**ED BELL CONSTRUCTION COMPANY**POST OFFICE BOX 540787  
DALLAS, TEXAS 75354-078710605 HARRY HINES  
DALLAS, TEXAS 75220

Mr. James C. Pierce, Jr., P.E.  
Assistant City Engineer  
Town of Addison  
P.O. Box 9010  
Addison, Texas 75001-9010Re: Arapaho Road Reconstruction  
Addison Road to Dallas North Tollway  
Town of Addison

Re: Final Billing

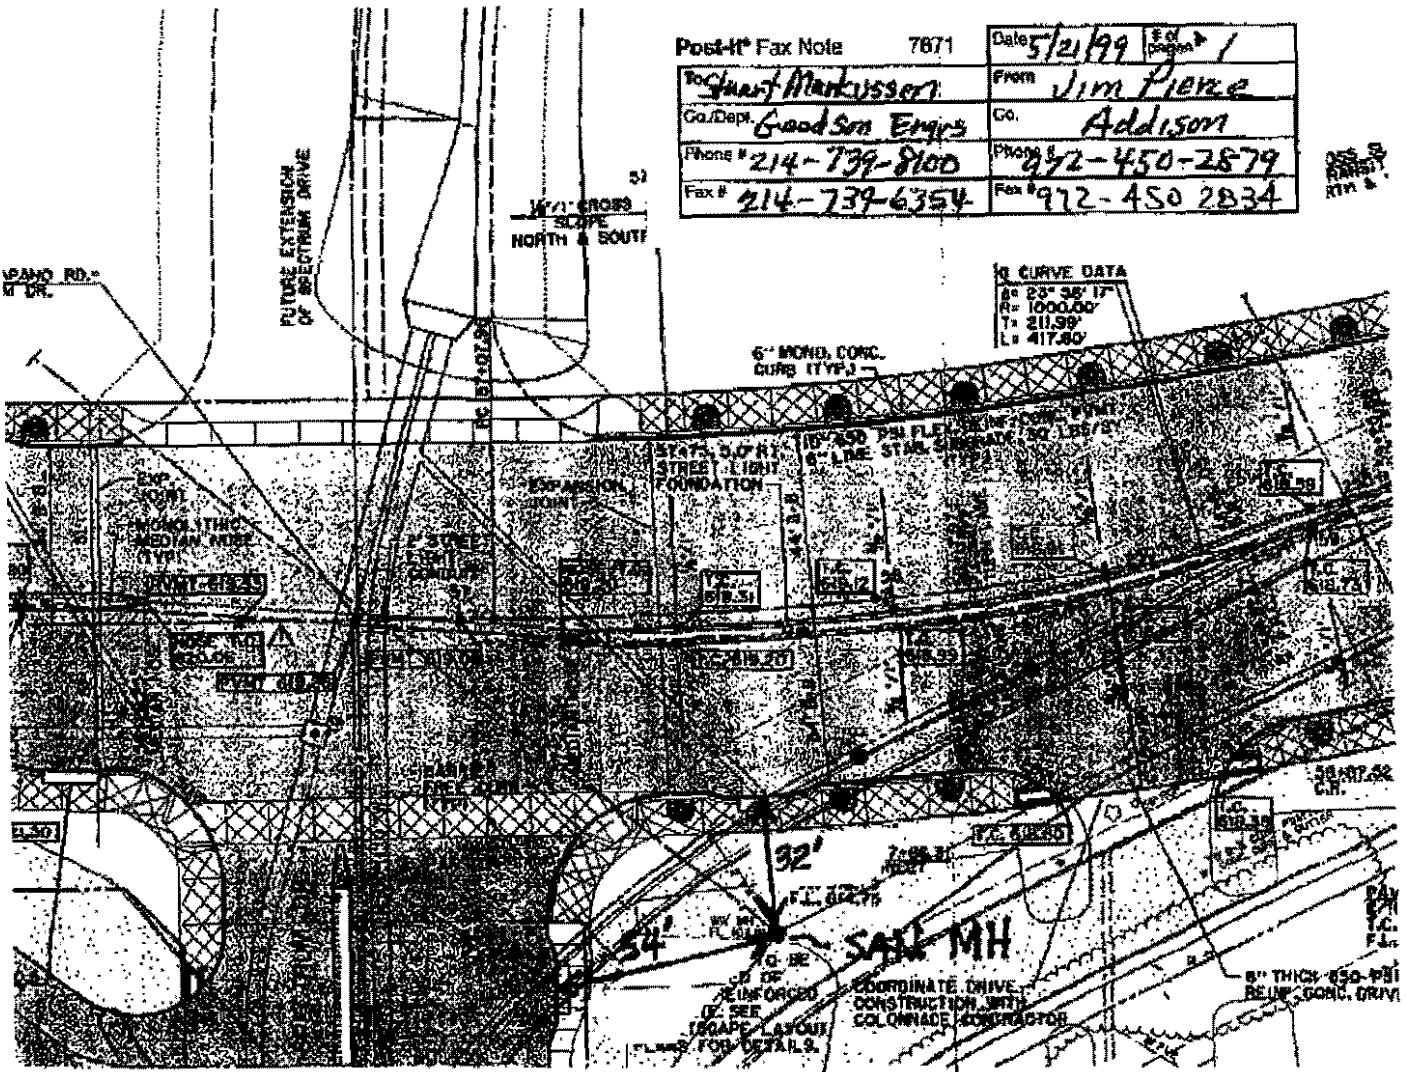
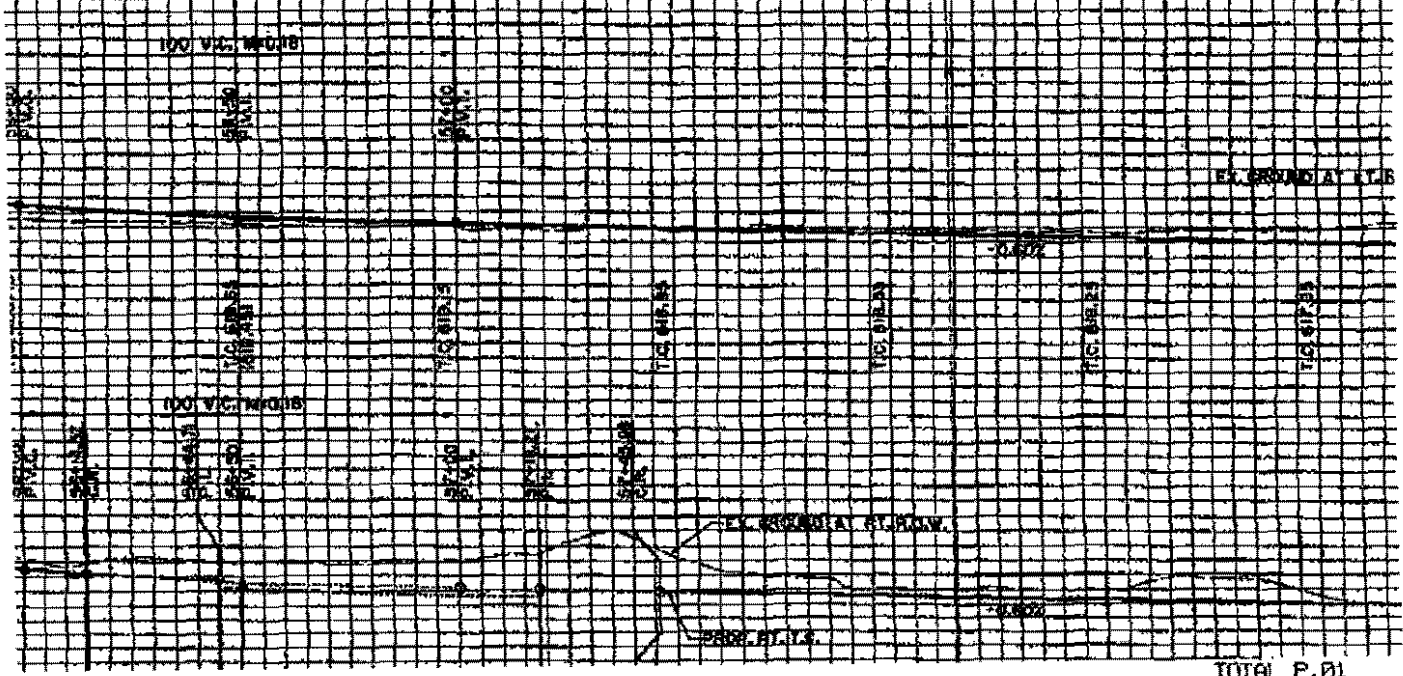
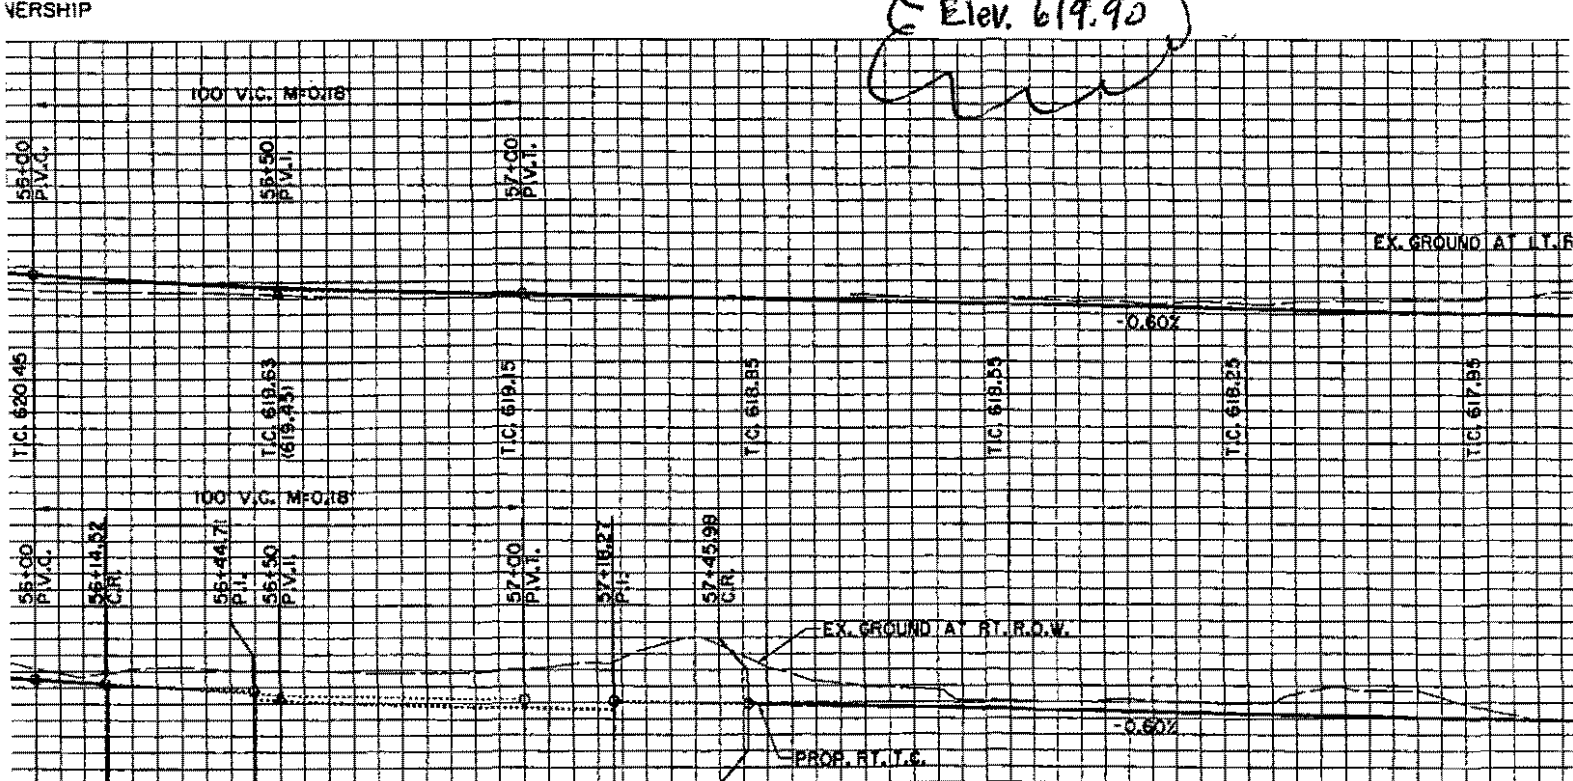
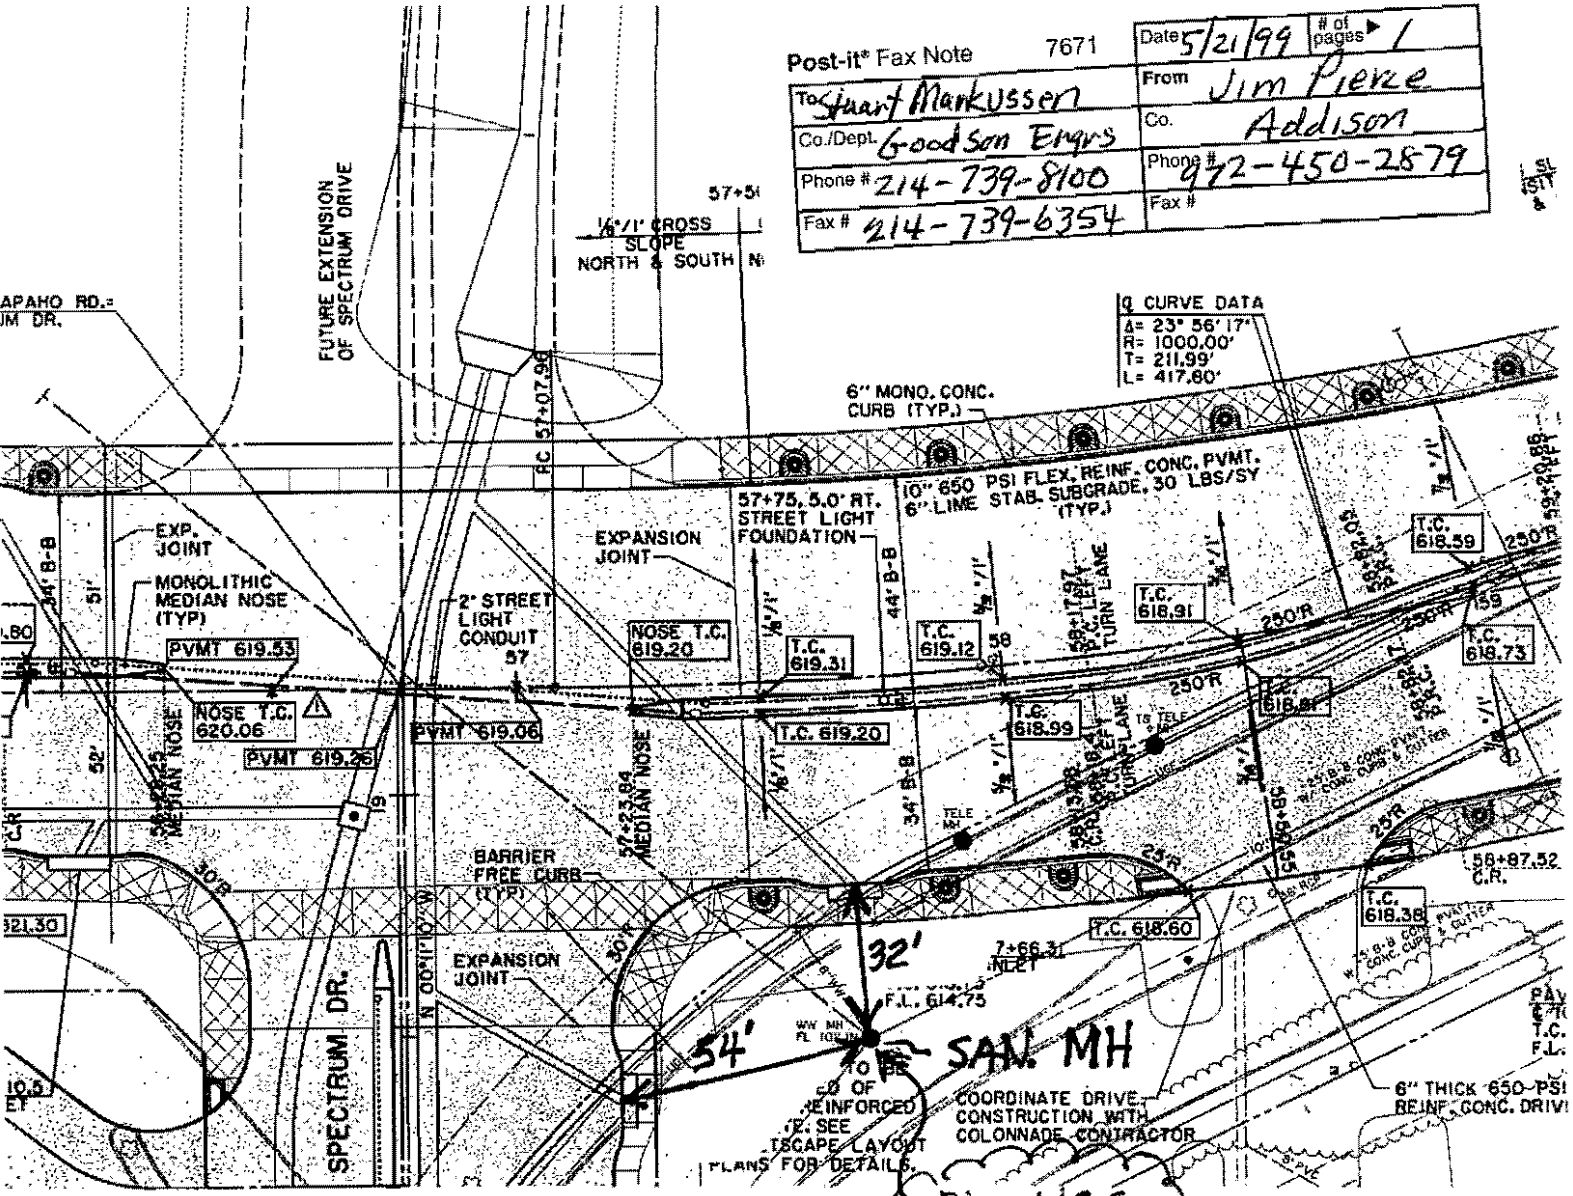
Call when cur removal is planned.

PVMT ELEV 619.90±

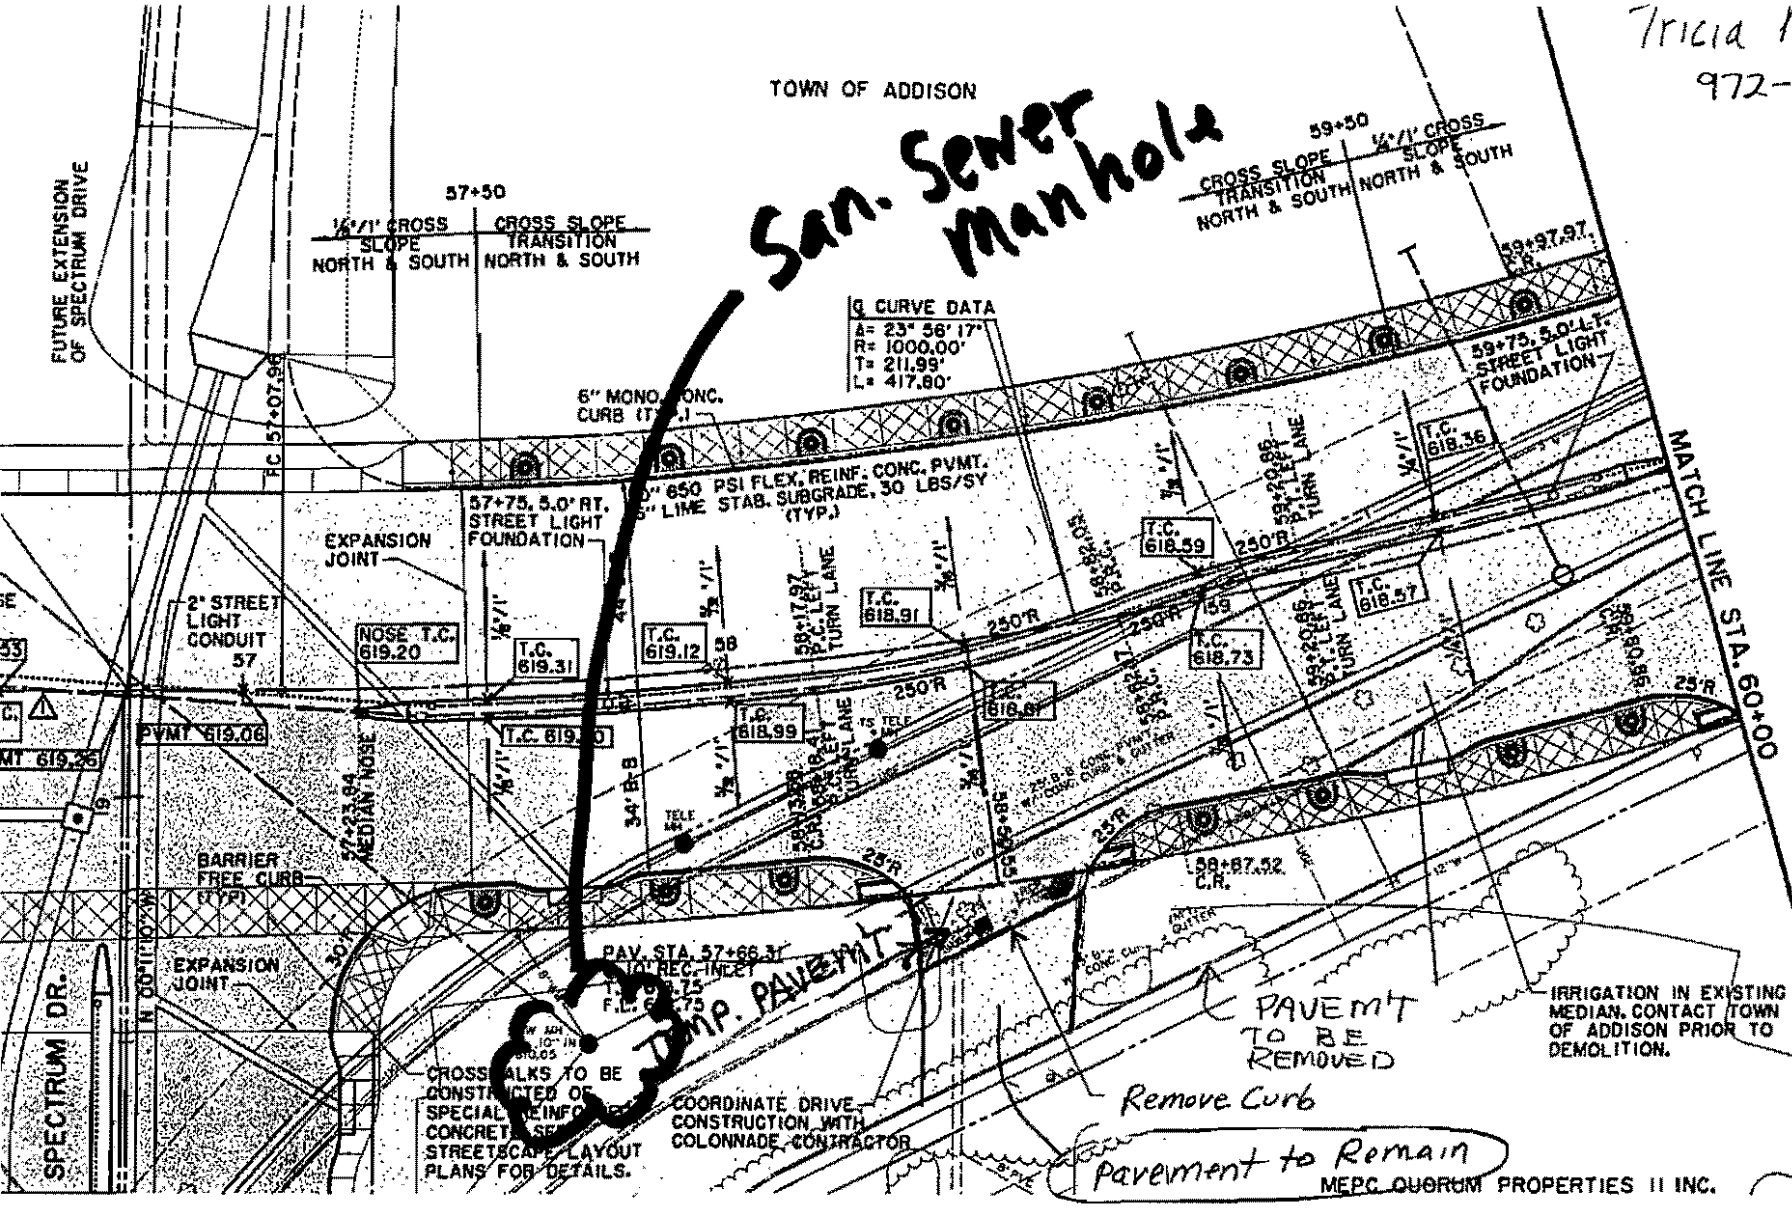
The sanitary sewer manhole  
shown on the attached needs to be  
adjusted to meet the final grade  
of your project. If you can  
have your Engineer give us a  
grade elevation for the top of the  
manhole we will make the adjustment.

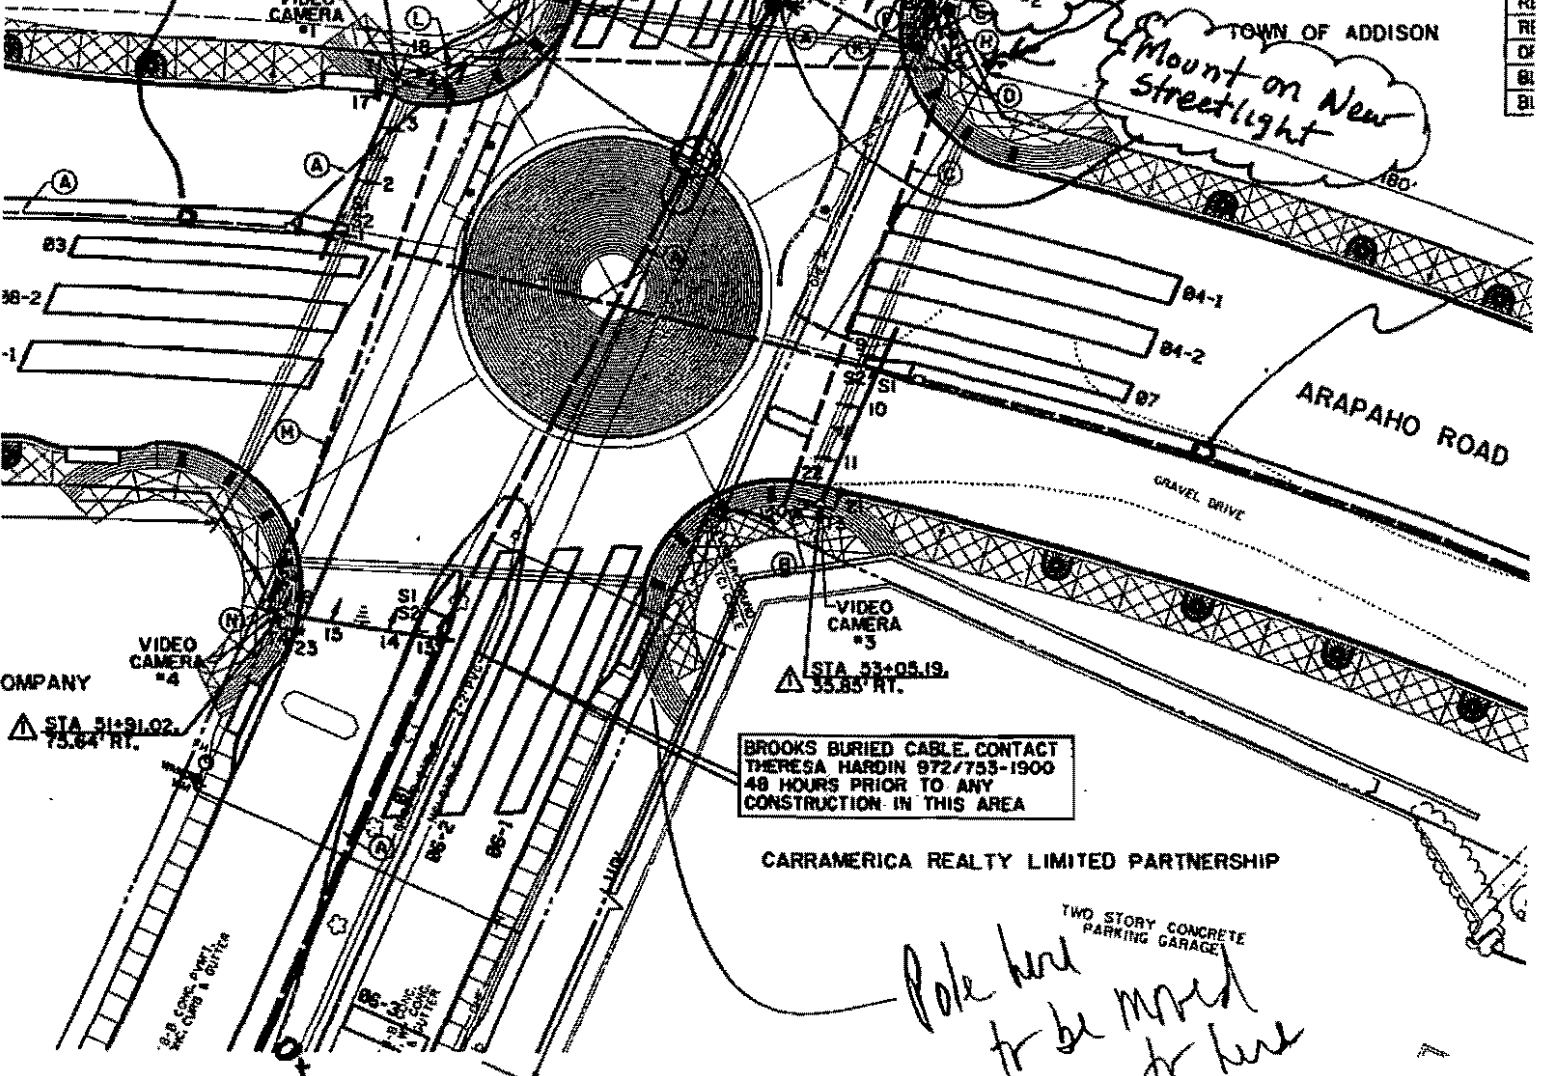
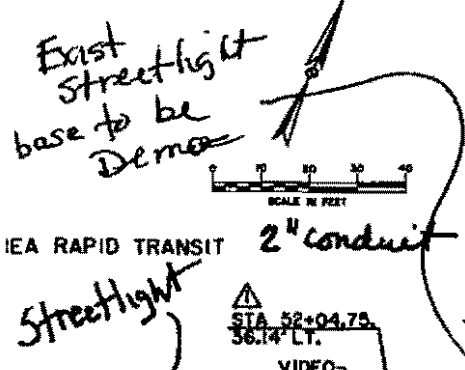
REMARKS One of the purposes of the new streetlight location is to provide a better mounting location for the video camera. We should have existing pay items for this work except for conduit up the streetlight for mounting the camera. Please incorporate this change into the work and advise of any additional charges.
